# ALERT SERVICE BULLETIN

**SUBJECT:** ROTOR FLIGHT CONTROL - Tail Rotor-, Cyclic- and Collective Controls

**Check bearings for correct attachment and retrofit of bushings and washers**

Revision No.	Date of issue
Revision 0	2008-04-28
Revision 1	2009-09-29
Revision 2	2009-10-07
Revision 3	2009-12-16
Revision 4	2017-04-03

Arrangement of Levers  
Figure 1

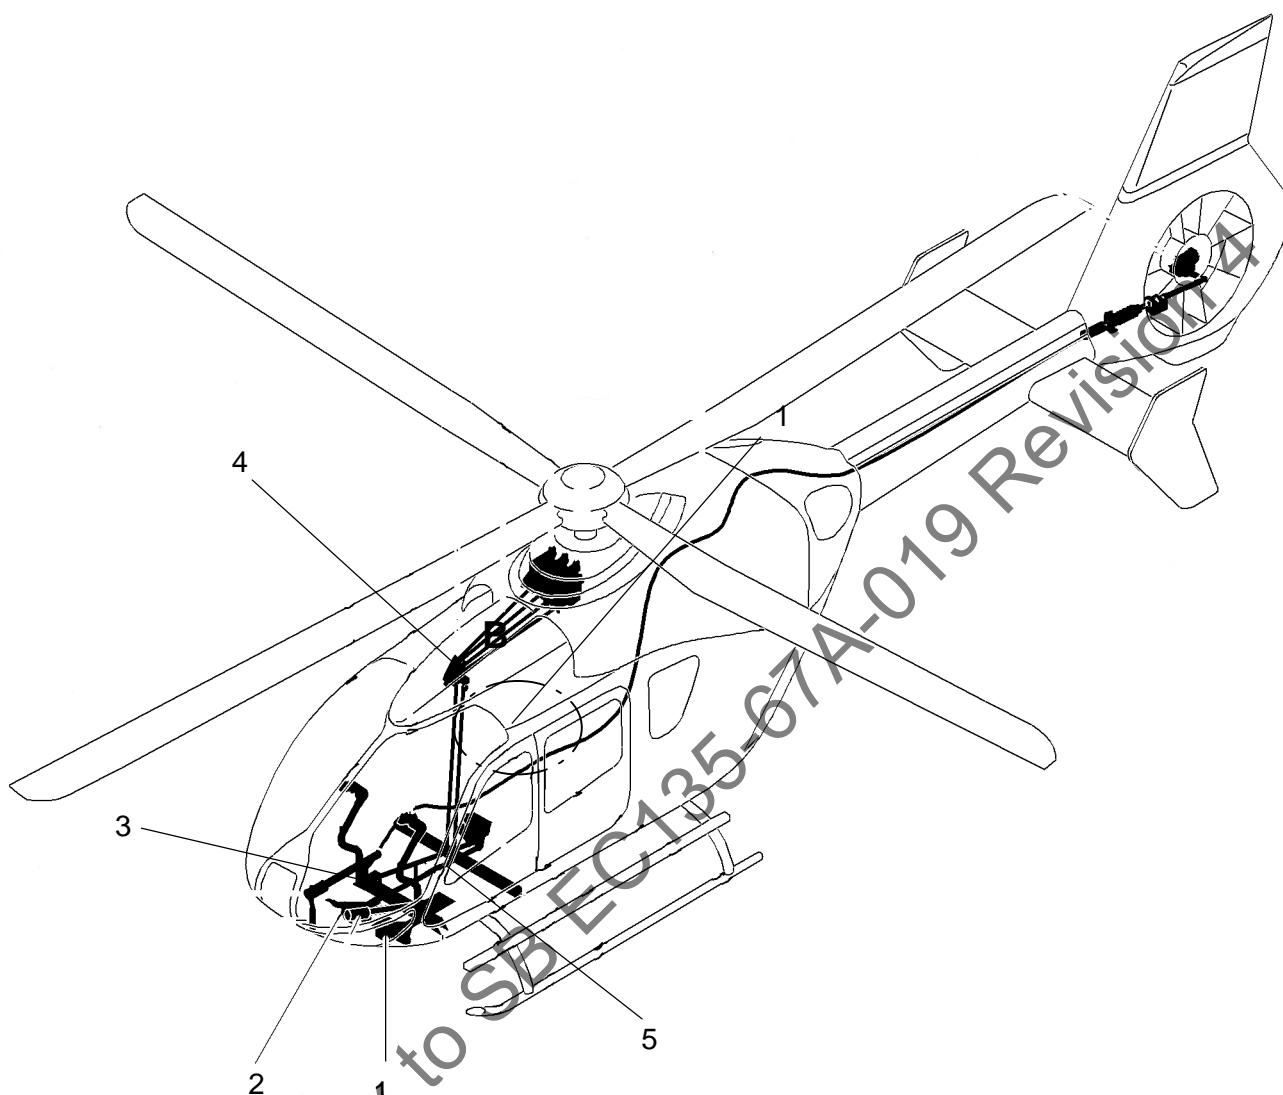
- 1 LH guidance unit – Detail A, Figure 2
- 2 RH guidance unit – Detail B, Figure 2
- 3 Lever, cyclic control – Detail C, Figure 3
- 4 Upper guidance unit – Detail D, Figure 3
- 5 LVDT – Detail E, Figure 4

Detail A and B of Figure 1  
Figure 2

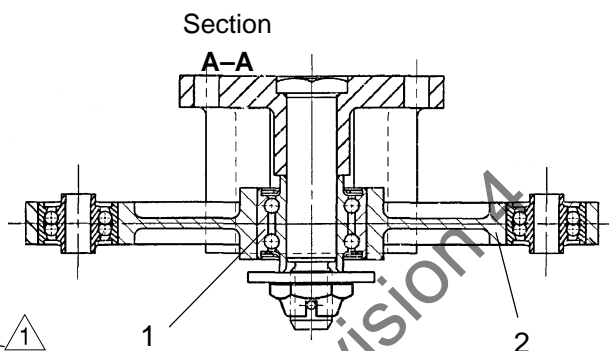
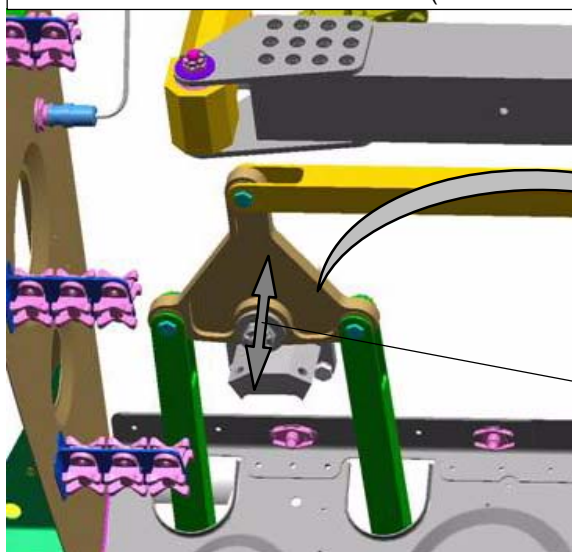
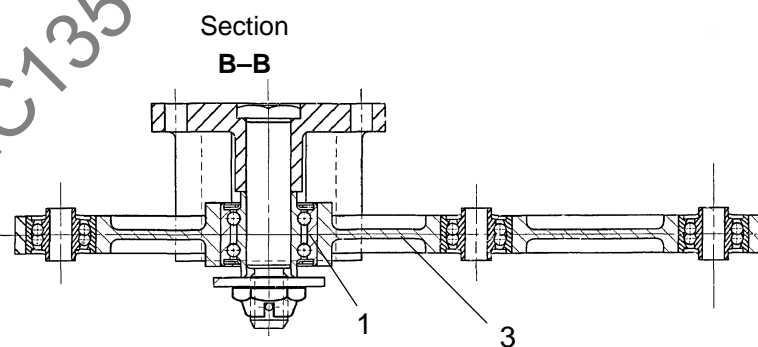
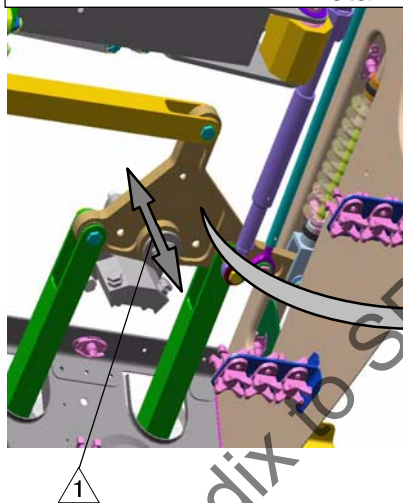
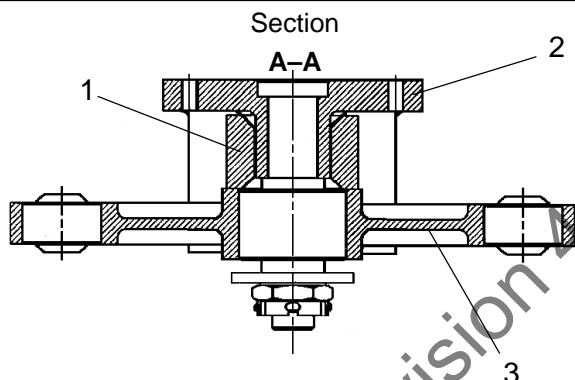
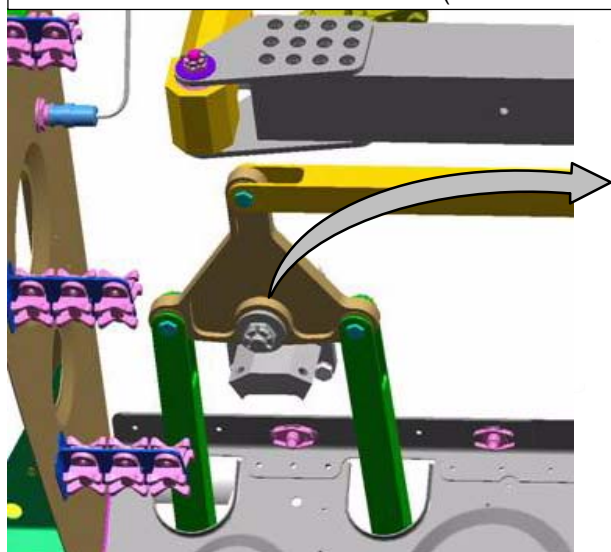
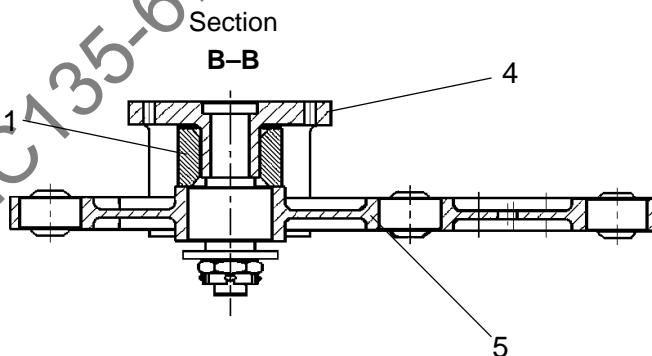
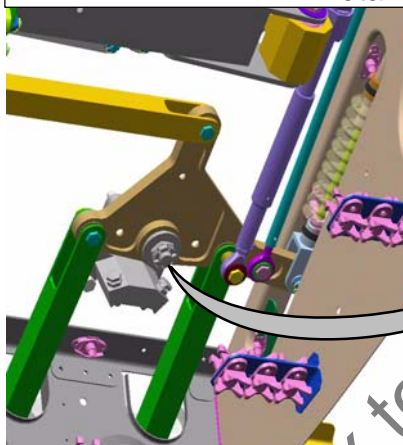
- (1) Check bearing in LH guidance unit (Detail A, Figure 2) for correct attachment.
  - (a) Check, whether bearing (1, Figure 2) is correctly installed in lever (2) as shown in Section A–A.

- (b) Manually check, whether bearing (1) is tightly fitted in lever (2). To do so, manually try to move lever in axial direction  $\triangle$ .
  - (c) If a loose bearing is detected, copy reply form sheet on page 14, fill out and send to ECD customer support. Rebond bearing i.a.w. AMM, 20-00-00, 2-14.

- (2) Check bearing in RH guidance unit (Detail B, Figure 2) for correct attachment.
  - (a) Check, whether bearing (1, Figure 2) is correctly installed in lever (3) as shown in Section B–B.

- (b) Manually check, whether bearing (1) is tightly fitted in lever (3). To do so, manually try to move lever (3) in axial direction  $\triangle$ .
  - (c) If a loose bearing is detected, copy reply form sheet on page 14, fill out and send to ECD customer support. Rebond bearing i.a.w. AMM, 20-00-00, 2-14.

- (1) Remove LH guidance unit i.a.w. AMM, 67-20-00, 4-4.
- (2) Disassemble LH guidance unit i.a.w. AMM, 67-20-00, 4-5.
- (3) Assemble LH guidance unit i.a.w. AMM, 67-20-00, 4-5. While doing so, additionally install bushing (1, Figure 5) between bearing block (2) and lever (3) (see Detail A, Figure 5) – notwithstanding the instructions given in the AMM.
- (4) Install LH guidance unit i.a.w. AMM, 67-20-00, 4-4.

- (5) Remove RH guidance unit i.a.w. AMM, 67-20-00, 4-4.
- (6) Disassemble RH guidance unit i.a.w. AMM, 67-20-00, 4-5.
- (7) Assemble RH guidance unit i.a.w. AMM, 67-20-00, 4-5. While doing so, additionally install bushing (1, Figure 5) between bearing block (4) and lever (5) (see Detail B, Figure 5) – notwithstanding the instructions given in the AMM.
- (8) Install RH guidance unit i.a.w. AMM, 67-20-00, 4-4.

Detail C and D of Figure 1  
Figure 3

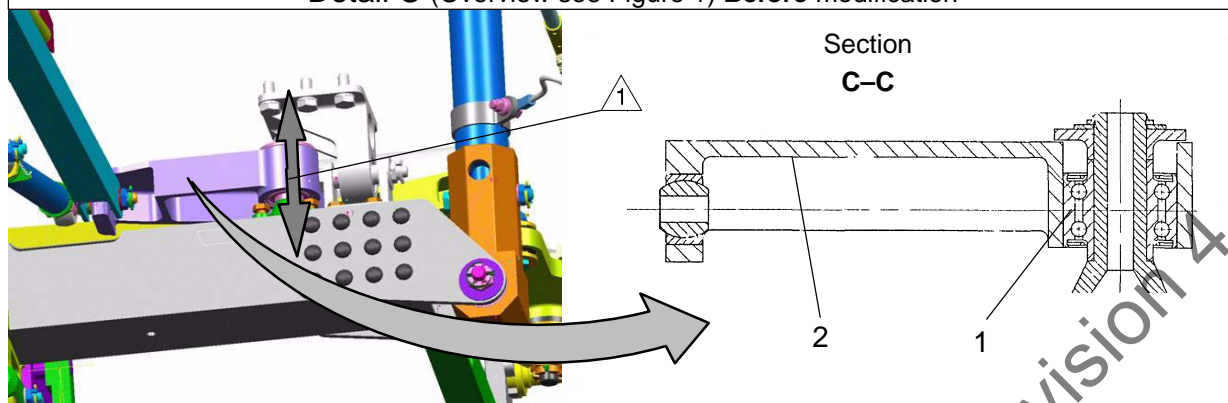
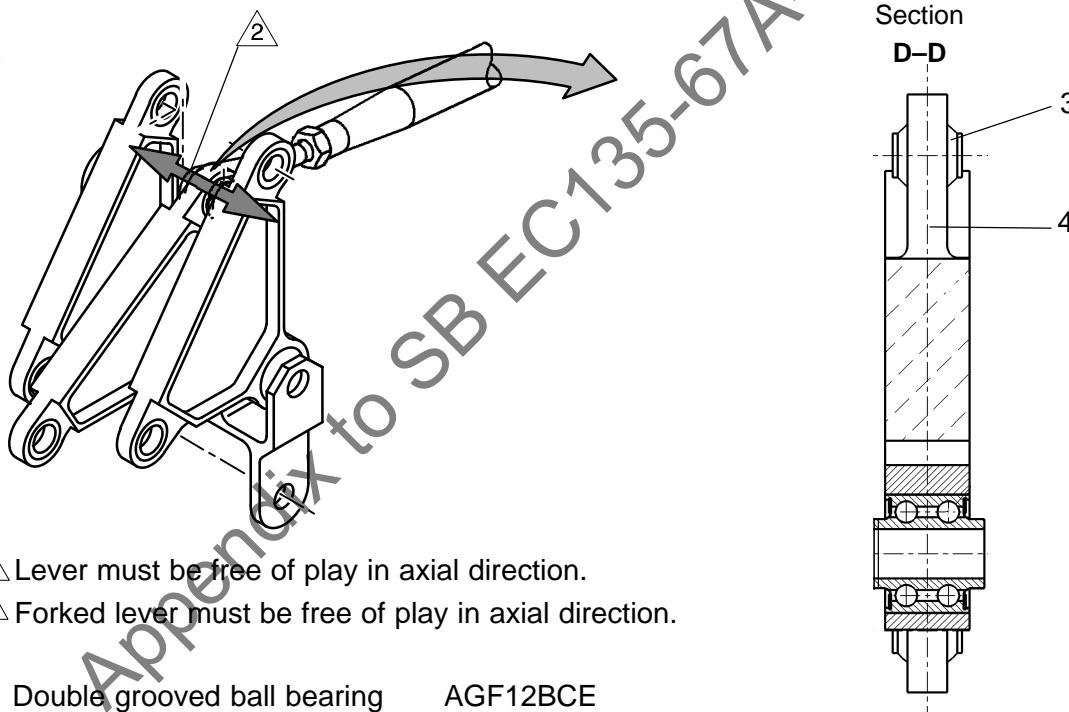
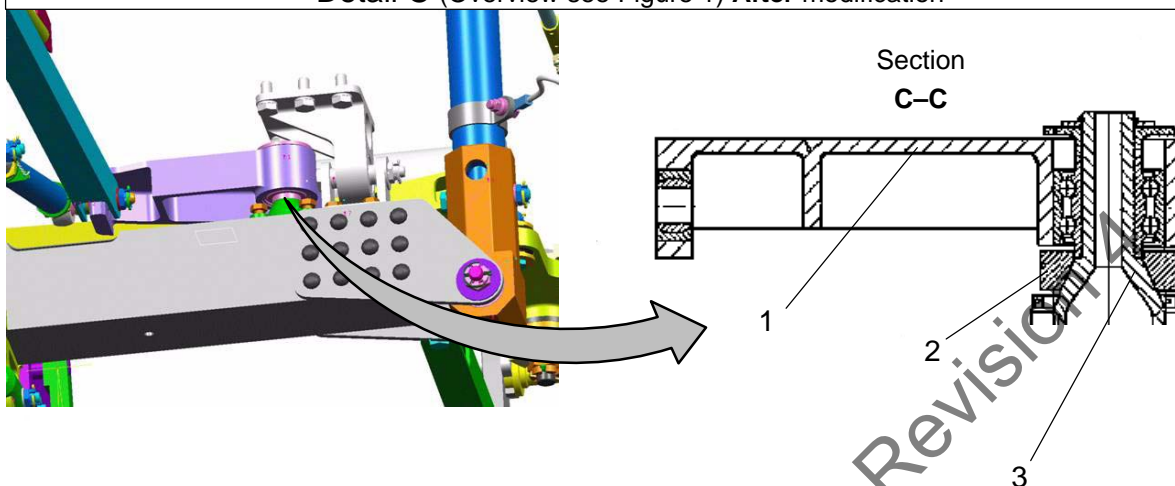
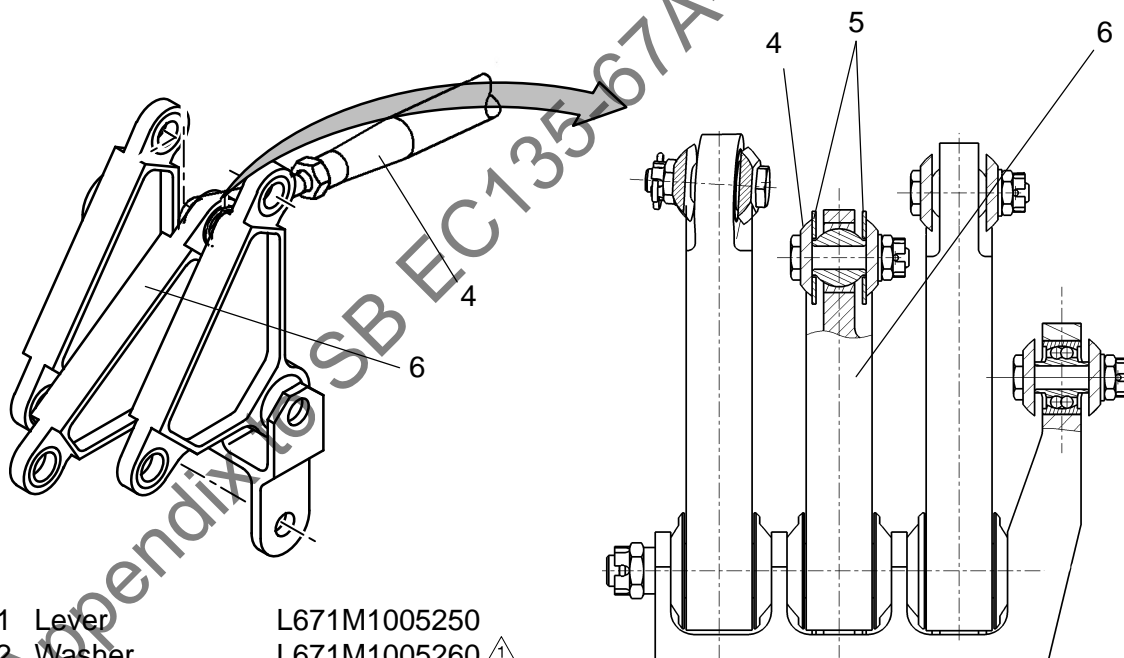
- (3) Check bearing of cyclic control (Detail C, Figure 3) for correct attachment.
  - (a) Check, whether bearing (1, Figure 3) is correctly installed in lever (2) as shown in Section C–C.

- (b) Manually check, whether bearing (1, Figure 3) is tightly fitted in lever (2). To do so, manually try to move lever in axial direction  $\triangle$ .

- (4) Check bearing of upper guidance unit (Detail D, Figure 3) for correct attachment.
  - (a) Check, whether bearing (3, Figure 3) is correctly installed in lever (4) as shown in Section D–D.

- (b) Manually check, whether bearing (3, Figure 3) is tightly fitted in lever (4). To do so, manually try to move connected forked end in axial direction  $\triangle$ .

- (9) Remove cyclic shaft i.a.w. AMM, 67-11-00, 4-5.
- (10) Disassemble the cyclic shaft i.a.w. AMM, 67-11-00, 4-6. While you do so, disassemble the cyclic shaft only as far as necessary for the retrofit of the washer (2, figure 6).
- (11) Assemble cyclic shaft i.a.w. AMM, 67-11-00, 4-6. While doing so, additionally install washer (2, Figure 6) between bearing block (3) and lever (1) (see Detail C, Figure 6) – notwithstanding the instructions given in the AMM.
- (12) Install cyclic shaft i.a.w. AMM, 67-11-00, 4-5.

- (13) Remove collective control rod (4, Figure 6) from bellcrank i.a.w. AMM, 67-10-00, 4-2. While doing so, remove the collective control rod (4) only as far as necessary for the retrofit of the washers (5).
  - (14) Install collective control rod (4, Figure 6) at the bellcrank i.a.w. AMM, 67-10-00, 4-2. While doing so, additionally install washers (5) between collective control rod (4) and bellcrank (6) (see Detail D, Figure 6) – notwithstanding the instructions given in the AMM.
- D. Conclusive work:
- (1) Accomplish inspection for foreign objects and for foreign matter.
  - (2) Install forward access cover i.a.w. AMM, 52-40-00, 4-3.
  - (3) If removed, install equipment plate i.a.w. AMM, 25-70-00, 4-2.
  - (4) Install middle cover i.a.w. AMM, 52-40-00, 4-4.
- E. Confirm accomplishment of this Alert Service Bulletin by an entry in the historical record of the helicopter.

Detail E of Figure 1  
Figure 4

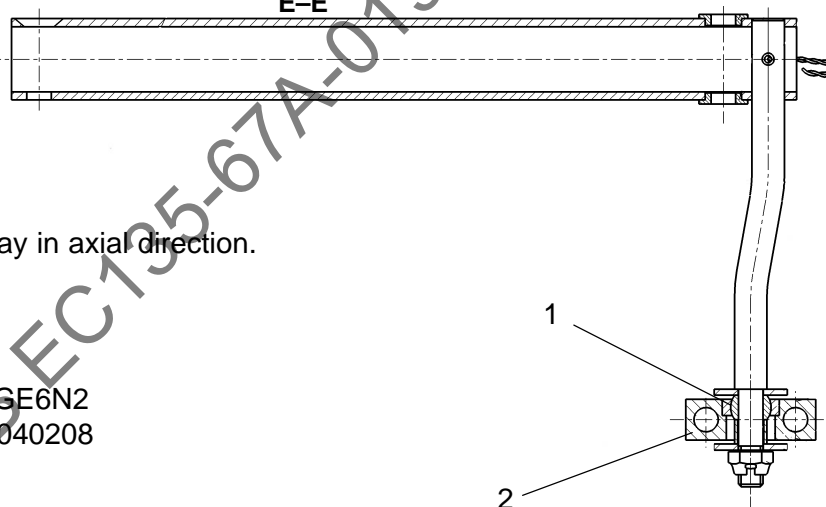
- (c) If a loose bearing is detected, copy reply form sheet on page 14, fill out and send to ECD customer support. Rebond bearing i.a.w. AMM, 20-00-00, 2-14.
- (5) Check bearing in LVDT plate (Detail E, Figure 4) for correct attachment.
  - (a) Check, whether bearing (1, Figure 4) is correctly installed in plate (2) as shown in Section E-E.
  - (b) Manually check, whether bearing (1, Figure 4) is tightly fitted in plate (2). To do so, manually try to move plate (2) in axial direction  $\triangle$ .
  - (c) If a loose bearing is detected, copy reply form sheet on page 14, fill out and send to ECD customer support. Rebond bearing i.a.w. AMM, 20-00-00, 2-14.

△ Plate (2) must be free of play in axial direction.
